STAFF RECOMMENDATION 2121 West Linden Avenue February 17, 2016

Application: New construction—outbuilding; Setback determination
District: Hillsboro-West End Neighborhood Conservation Zoning Overlay
Council District: 18
Map and Parcel Number: 10415032700
Applicant: Anna Teeples, Anna Teeples Designs
Project Lead: Melissa Sajid, melissa.sajid@nashville.gov

Description of Project: Application is to construct an outbuilding. The request includes a setback determination for the rear setback of three feet (3'). The request does not include a detached accessory dwelling unit.

FRONT ELEVATION
 DETACHED UNIT

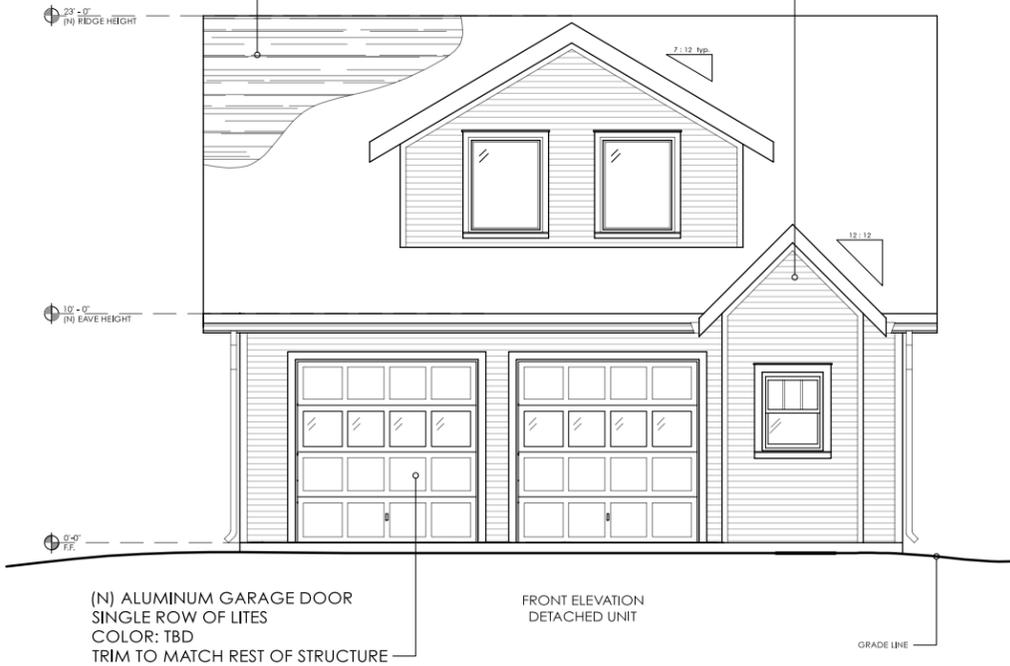
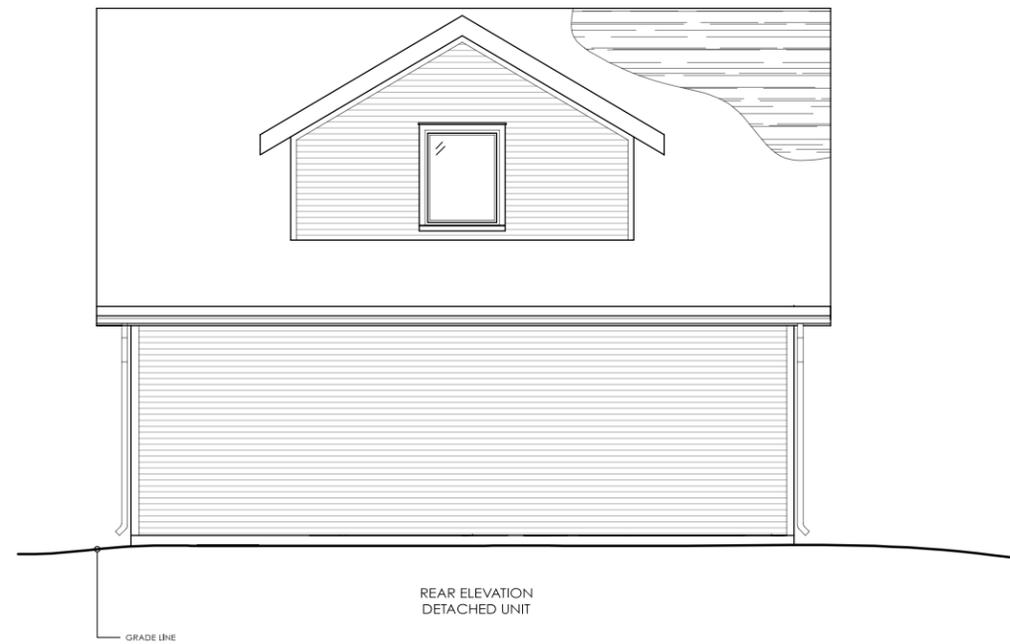
The proposed materials are Hardie-plank siding with a reveal of four inches (4”). The roof shingles will be architectural shingles. The garage doors will be aluminum. The garage will sit on a concrete block. Staff asks to approve the final selection of door and windows.

1. Staff approve the final details, dimensions and materials of windows and doors prior to purchase and installation; and
2. Staff approve the roof color.
